Seventieth session

Advanced Emergency Braking Systems

Proposal for 01 Series of amendments to the Draft Regulation on advanced emergency braking systems

**Submitted by the Informal group on Advanced Emergency Braking
and Lane Departure Warning Systems ***

"Annex 2

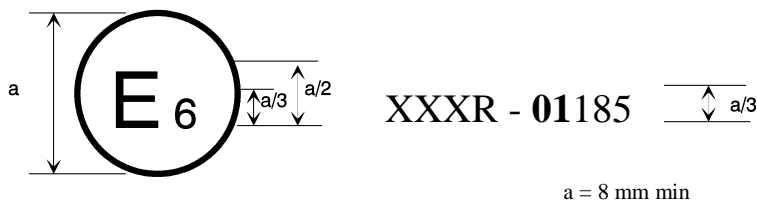
Annex 2, amend to read:

The above approval mark affixed to a vehicle shows that the vehicle type concerned has been approved in Belgium (E6) with regard to the AEBS pursuant to Regulation

No. XXX. The first two digits of the approval number indicate that the approval was granted in accordance with the requirements of **the 01 Series of Amendments to the Regulation No. XXX in its original form.**"
